06-38 – 2021

Proponent: Kyle Thompson, Plumbing Manufacturers International (PMI)

607.2, 607.3(New), 607.5, Figures 607.2(A), 607.2(B), 607.3(New), 607.5, 1103.2.5.1(A), 1103.2.5.1(B)

1104.11.3.1.3, 1104.11.3.1.3.1, 1104.11.3.1.3.2, 1104.11.3.1.3.3, 1104.11.3.2.3.1; Figures 1104.11.3.1.3.1, 1104.11.3.1.3.2, 1104.11.3.1.3.3(A), 1104.11.3.1.3.3(B), 1104.11.3.2.3.1

FIGURE 607.2(A)

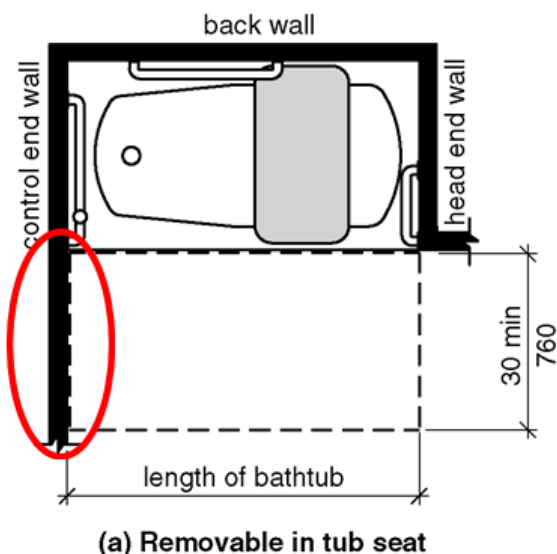
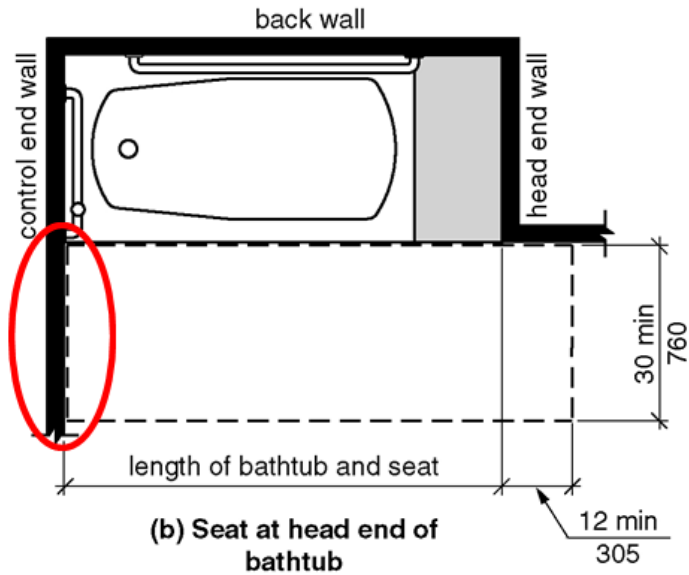
Note: The wall in the Figures 607.2(A) and 607.2(B) would be jogged to indicate the additional 4 inch toe clearance in the new Figure 607.3. The committee will need to decide if Figures 607.2(A) and 607.2 (B) should be revised to show the control clearance with the transfer clearance or if the control clearance should be in a separate Figure 607.3. The figure submitted indicates the transfer clearance moving forward, not an addition 4 inch control clearance as the text indicates.

FIGURE 607.3
CLEARANCE FOR BATHTUBS CONTROLS

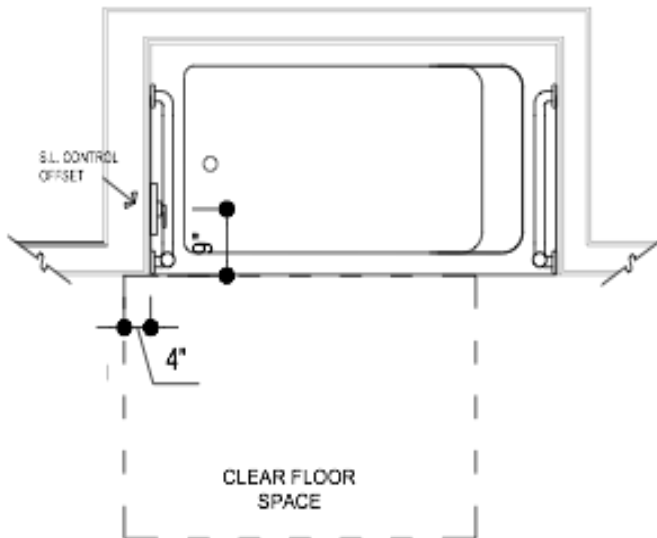
607.3 Control Clearance. The clear floor space for toe clearance at the controls shall extend 4 inches (100 mm) minimum beyond the control end wall.

REASON: Based on anthropometry, the provision of toe space past the control end of the fixture accomplishes realistic reach of the control for 90% of persons measured. In existing buildings “technical infeasibility” provides an exception for difficult situations.

**FIGURE 607.5
LOCATION OF BATHTUB CONTROLS**

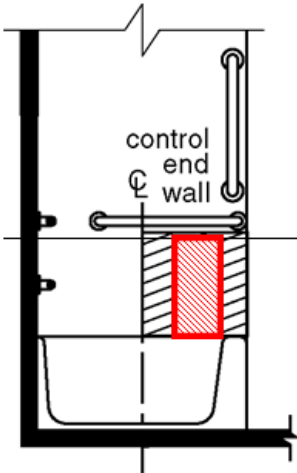
Note: The area for the controls in Figure 607.5 would be revised to the smaller area indicated in the revised text.

607.5 Controls. Controls, other than drain stoppers, shall be provided on an end wall, located between the bathtub rim and grab bar, and between the open side of the bathtub and the centerline of the width of the bathtub the centerline of controls measured from the approach side of the bathtub shall be located 5 inches (127 mm) minimum and 9 inches (229 mm) maximum from the clear floor space. Controls shall comply with Section 309.4.

Figure 1103.11.2.5.1(A)
CLEARANCE FOR BATHTUBS IN TYPE A UNITS WITH REMOVABLE SEATS

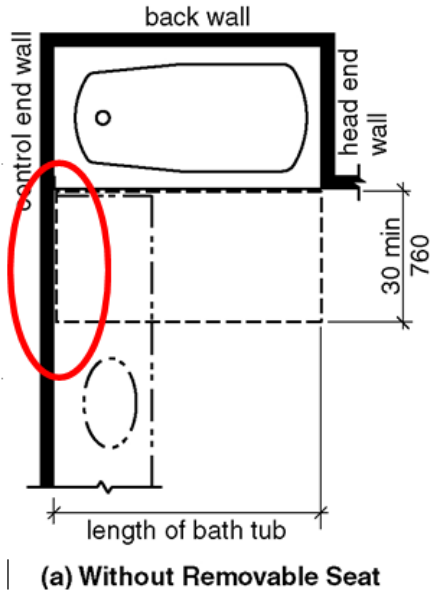
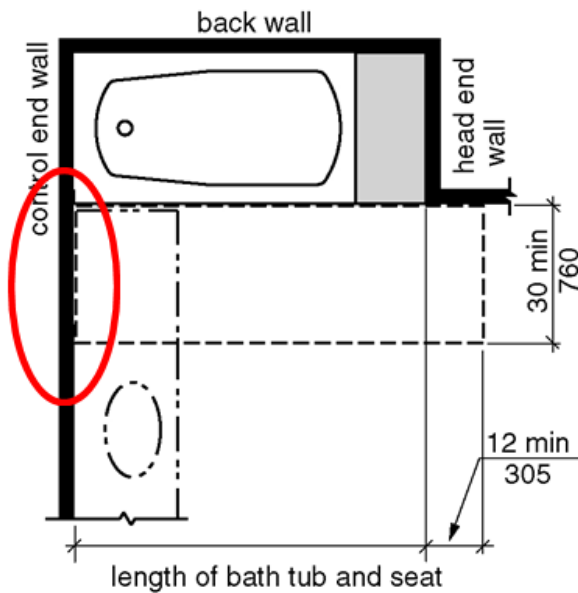
Note: The wall in the Figures 1103.11.2.5.1(A) and 1103.11.2.5.1(B) would be jogged to indicate the additional 4 inch control clearance in the new Figure 607.2.1

FIGURE 607.3
CLEARANCE FOR BATHTUBS CONTROLS

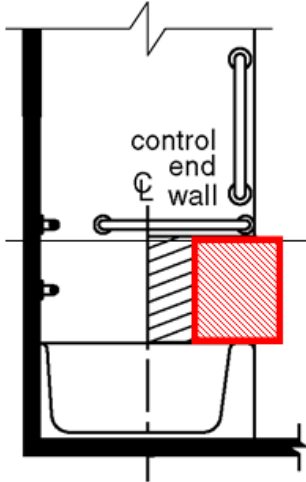
Note: This is a replacement figure. The clear floor space location was revised in the figure, but the location of the valve does not match the text in Section 607.5.

607.3 Control Clearance. The clear floor space for toe clearance complying with Section 306.2 at the controls shall extend 4-6 inches (100-152 mm) minimum beyond the control end wall. An obstruction by the control wall of 4 inches (102 mm) maximum shall be permitted.

FIGURE 608.2.1.2(A)
TRANSFER-TYPE SHOWER COMPARTMENT TRANSFER CLEARANCES
NEW BUILDINGS –OPTION 1

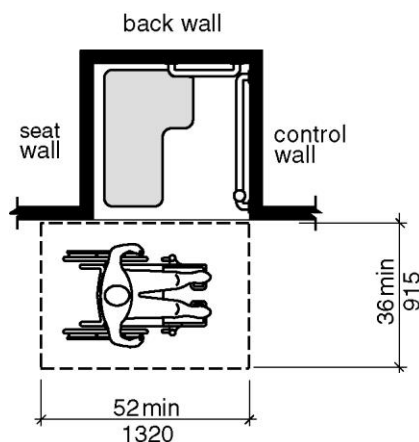
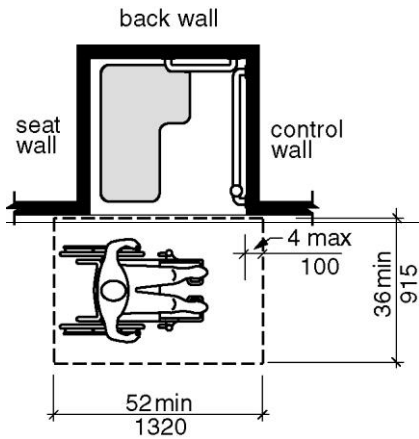
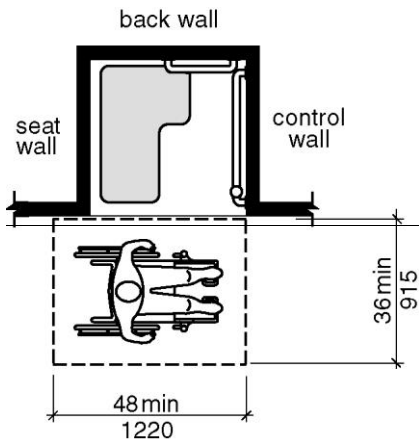
Note: The committee will need to decide if Figures 608.2.1.2(A), 608.2.1.2(B) and 608.2.1.2(C) should be revised to show the control clearance with the transfer clearance or if the control clearance should be in a separate Figure 608.2.1.3. The figure submitted indicates the clearance moving forward, not an addition 4 inch toe clearance as the text indicates.

FIGURE 608.2.1.3
TRANSFER-TYPE SHOWER COMPARTMENT
CLEARANCES FOR SHOWER CONTROLS

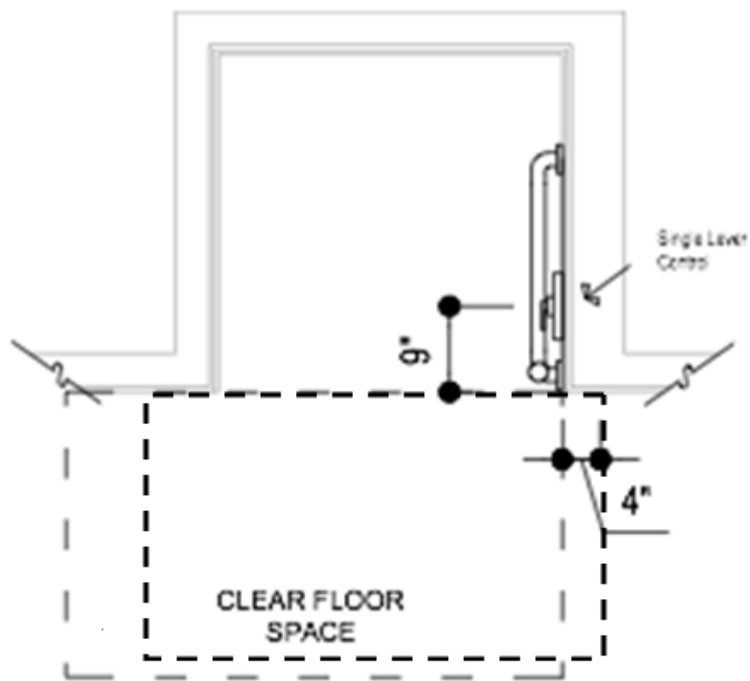
608.2.1.3 Control Clearance. The clear floor space for toe clearance at the controls shall extend 4 inches (100 mm) minimum beyond the control end wall.

Note: Figure needs to show 6" instead of 4" offset

608.2.1.3 Control Clearance. The clear floor space for toe clearance complying with Section 306.2 at the controls shall extend 4-6 inches (~~100~~ 152 mm) minimum beyond the control end wall.

**FIGURE 608.4.1
TRANSFER-TYPE SHOWER CONTROLS AND
HAND SHOWER LOCATION**

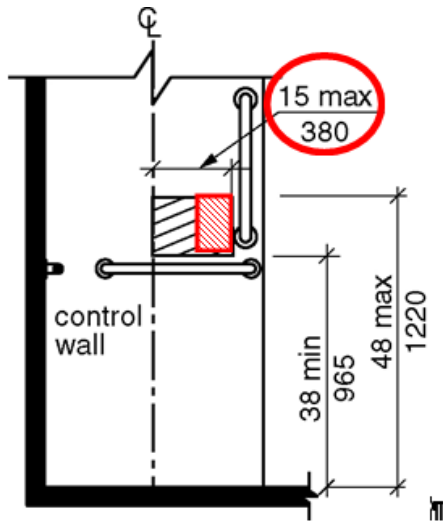
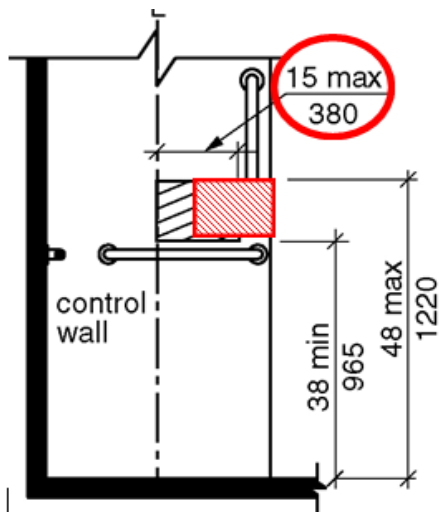
Note: The area for the controls in Figure 608.4.1 would be revised to the smaller area indicated in the revised text. Figure 608.3.1(B) indicates the vertical grab bar is 4 inches maximum to the center line of the bar. Section 609.2.1 indicates the diameter of the grab bar is 1-1/4" to 2". Since the control itself is past the control center line on both sides, the committee is requested to address the question of a possible overlap of the vertical grab bar with the controls.

Note: The area for the controls in Figure 608.4.1 would be revised to the smaller area indicated in the revised text. Figure 608.3.1(B) indicates the vertical grab bar is 4 inches maximum to the center line of the bar. Section 609.2.1 indicates the diameter of the grab bar is 1-1/4" to 2". Since the control itself is past the control center line on both sides, the committee is requested to address the question of a possible overlap of the vertical grab bar with the controls.

1. On the control wall opposite the seat.
2. At a height of 38 inches (965 mm) minimum and 48 inches (1220 mm) maximum above the shower floor, and
3. The centerline of controls measured from the approach side of the shower shall be located ~~5 inches (127 mm) minimum and~~ 9 inches (229 mm) maximum from the clear floor space.

FIGURE 1104.11.3.1.3.1
PARALLEL APPROACH BATHTUB IN TYPE B UNITS - OPTION A BATHROOM

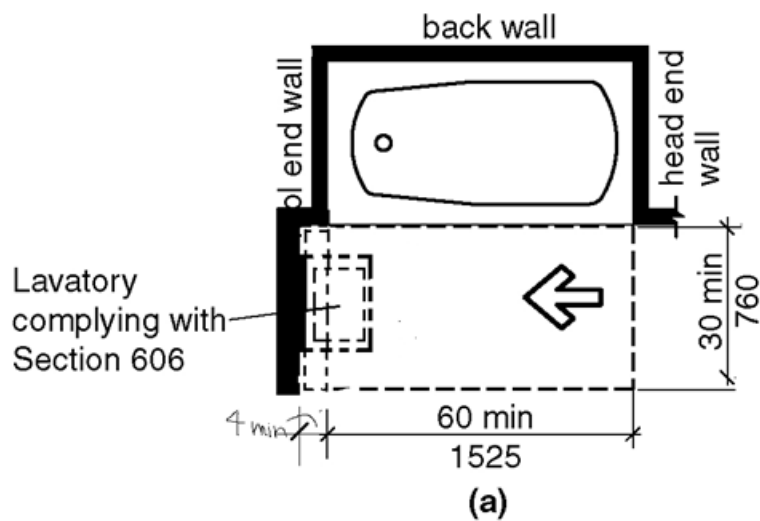
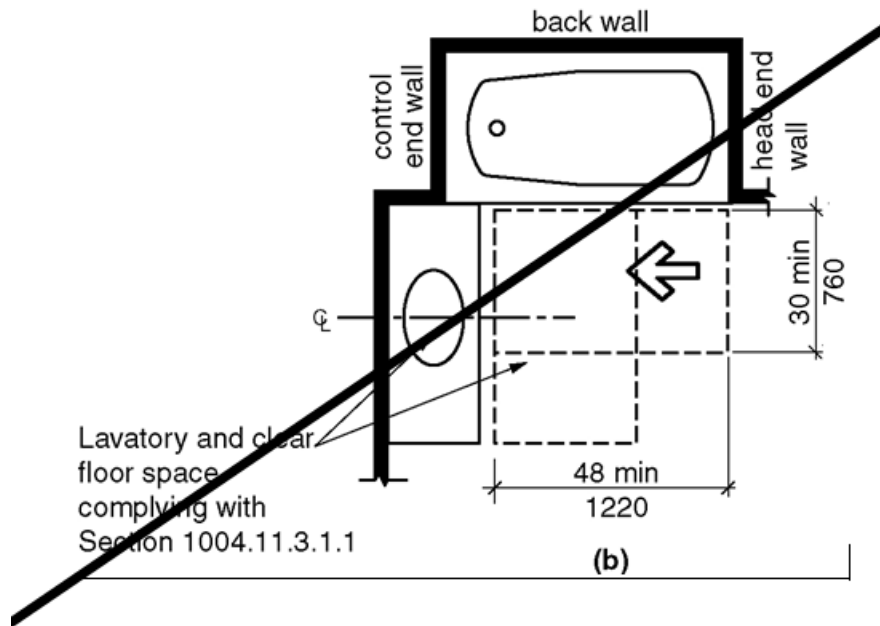
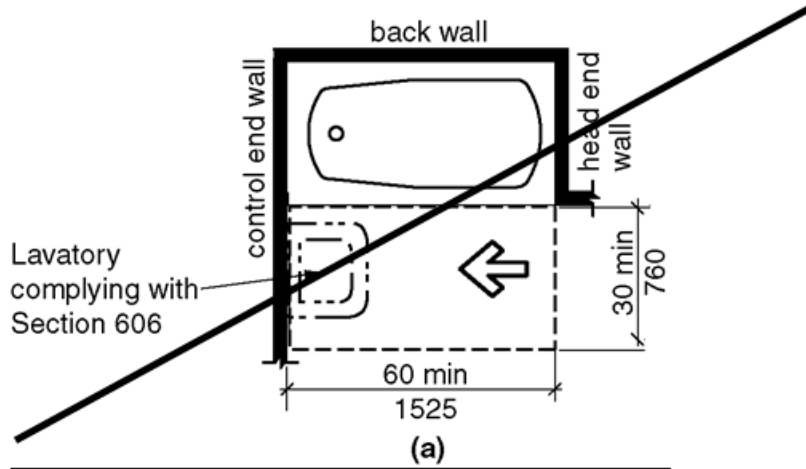
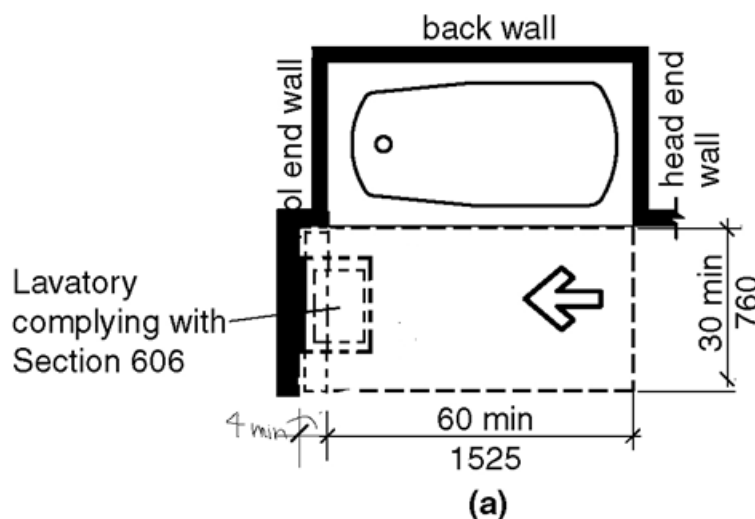
Note: Replace Figure 1104.11.3.1.3.1 (a) and (b) with one figure. The new figure indicates the transfer clearance and the additional 4 inches required for the control clearance.

Note: Replace Figure 1104.11.3.1.3.1 (a) and (b) with one figure. The new figure indicates the transfer clearance and the additional 4–6 inches required for the control clearance. Also need to add 4” obstruction.

1104.11.3.1.3.1 Parallel approach to bathtubs. A transfer clearance of 60 inches (1525 mm) minimum in length and 48" (1220 mm) minimum shall be provided in front of bathtubs with a parallel approach. A clear floor space for toe clearance at the controls shall extend 4 inch (102 mm) minimum beyond the control end wall. Lavatories complying with Section 606 shall be permitted in the transfer and control clearance. ~~A lavatory complying with Section 1104.11.3.1.1 shall be permitted if a clearance 48" (1220 mm) in length and 30 inches (760 mm) minimum in width is provided in front of the bathtub.~~

1104.11.3.1.3.1 Parallel approach to bathtubs. A transfer clearance of 60 inches (1525 mm) minimum in length and 48” (1220 mm) minimum shall be provided in front of bathtubs with a parallel approach. A clear floor space for toe clearance complying with Section 306.2 at the controls shall extend 4–6 inch (~~402~~ 152 mm) minimum beyond the control end wall. An obstruction by the control wall of 4 inches (102 mm) maximum shall be permitted.

**FIGURE 1104.11.3.1.3.2 ~~1104.11.3.1.3.3~~ (A)
TRANSFER-TYPE SHOWER COMPARTMENT IN TYPE B UNITS**

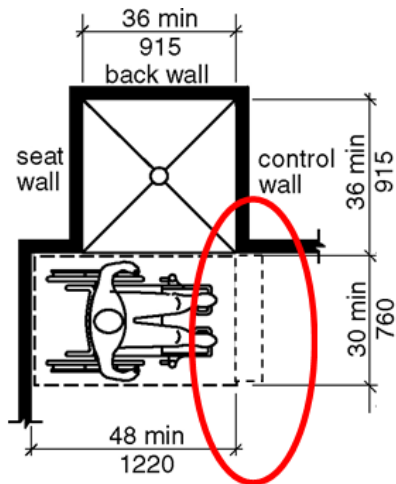
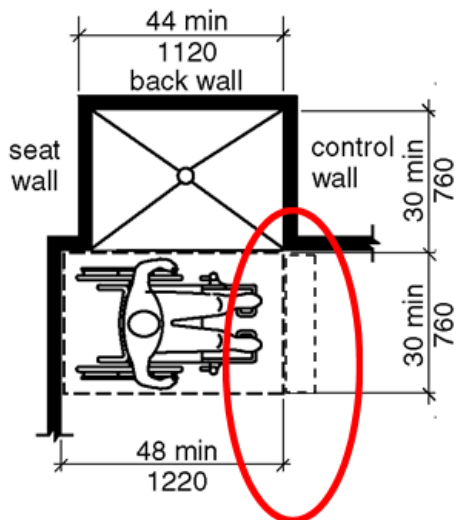
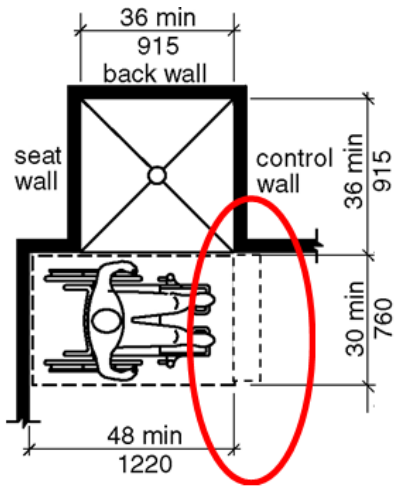
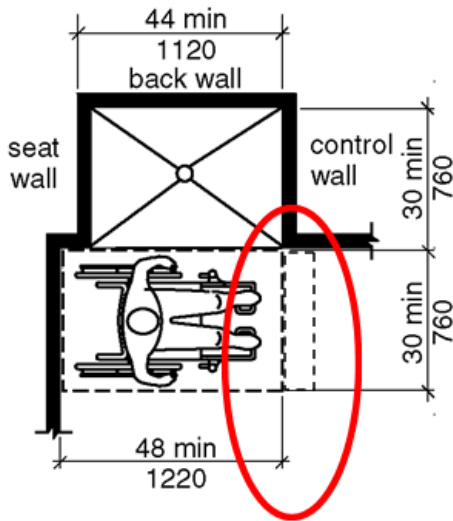
Note: The figure will be revised to add the 4 inch minimum control clearance to Figures (a) and (b). This would also apply if there is a wall at the toe end of the clearance.

Note: The figure will be revised to add the ~~4-6~~ inch minimum control clearance to Figures (a) and (b). This would also apply if there is a wall at the toe end of the clearance.

1104.11.3.1.3.2 1104.11.3.1.3.3 Shower compartments. If the shower compartment is the only bathing facility, the shower shall have dimensions of 36 inches minimum in width and 36 inches (915 mm) minimum in depth. A transfer clearance of 48 inches (1220 mm) minimum in length, measured perpendicular from the control wall, and 30 inches (760 mm) minimum in depth, measured from the face of the shower compartment, shall be provided. A clear floor space for toe clearance at the controls shall extend 4 inches (102 mm) minimum beyond the control end wall.

provided. A clear floor space for toe clearance complying with Section 306.2 at the controls shall extend ~~4-6~~ inches (~~102~~ 152 mm) minimum beyond the control end wall.

FIGURE 1104.11.3.2.3.1
BATHROOM CLEARANCE IN TYPE B UNITS OPTION B BATHROOM

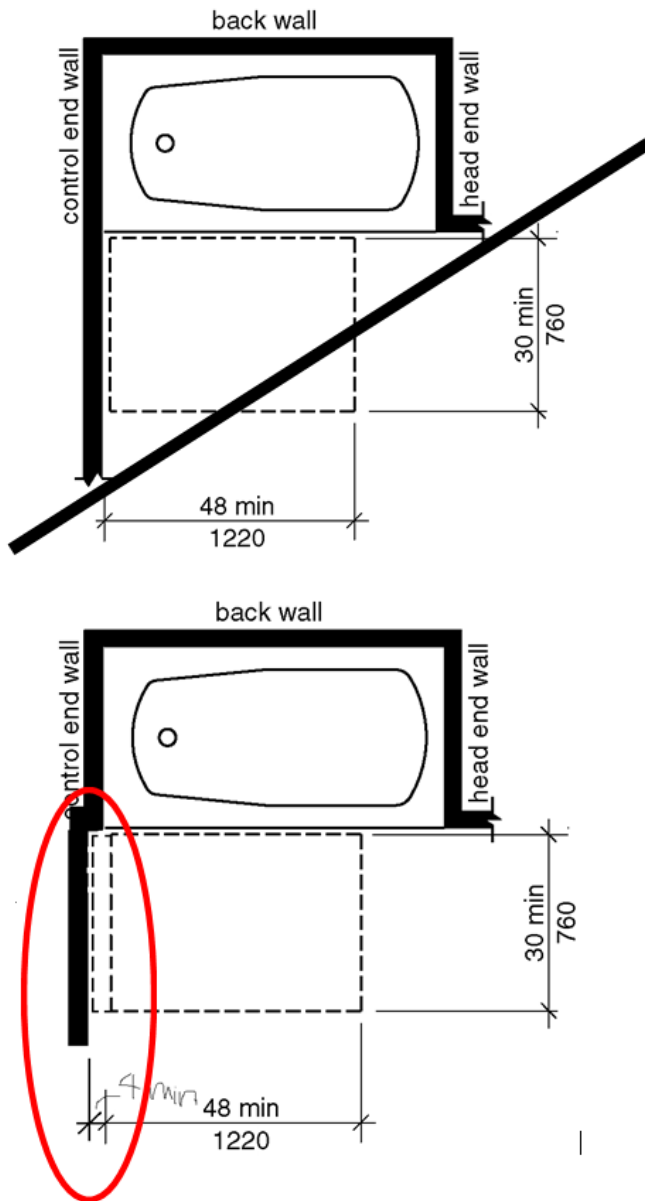
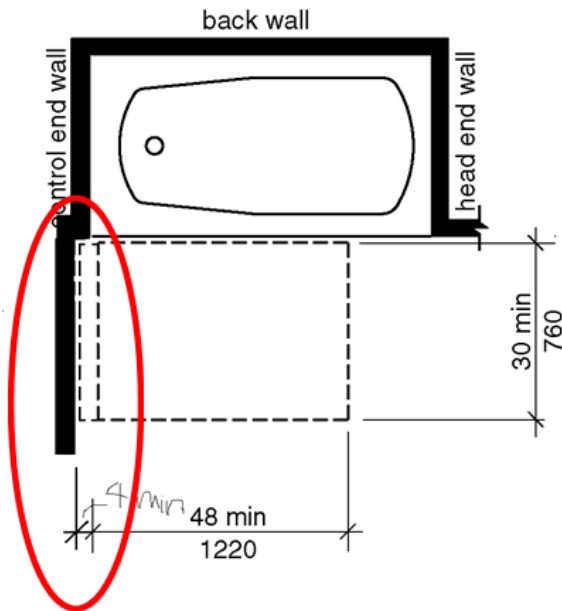
Note: Replace figure 1104.11.3.2.3.1 with the following. The figure will be revised to add the 4 inch minimum control clearance.

Note: Replace figure 1104.11.3.2.3.1 with the following. The figure will be revised to add the 4-6 inch minimum control clearance. Also need to add 4" obstruction.

1104.11.3.2.3.1 Bathtub. A transfer clearance 48 inches (1220 mm) minimum in length measured perpendicular from the control end of the bathtub, and 30 inches (760 mm) minimum in width shall be provided in front of bathtubs. A clear floor space for toe clearance at the controls shall extend 4 inches (102 mm) minimum beyond the control end wall.

1104.11.3.2.3.1 Bathtub. A transfer clearance 48 inches (1220 mm) minimum in length measured perpendicular from the control end of the bathtub, and 30 inches (760 mm) minimum in width shall be provided in front of bathtubs. A clear floor space for toe clearance complying with Section 306.2 at the controls shall extend 4-6 inches (402 152 mm) minimum beyond the control end wall. An obstruction by the control wall of 4 inches (102 mm) maximum shall be permitted.

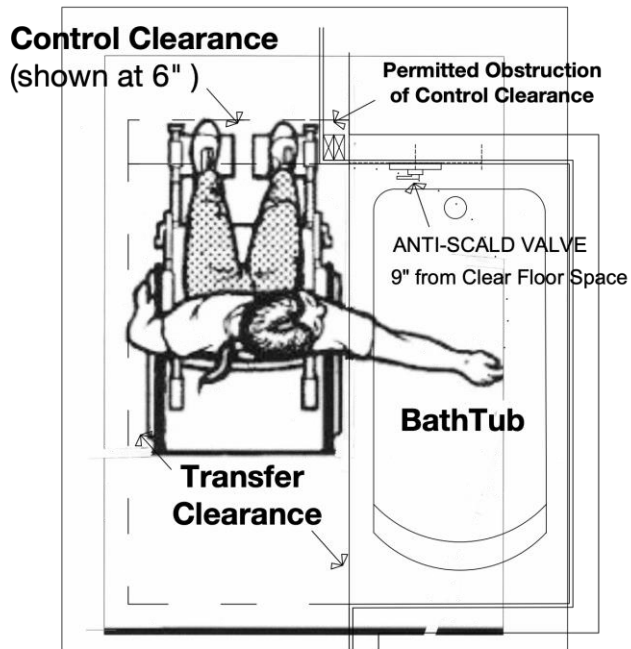
Note: Use this figure for guidance to revise figures
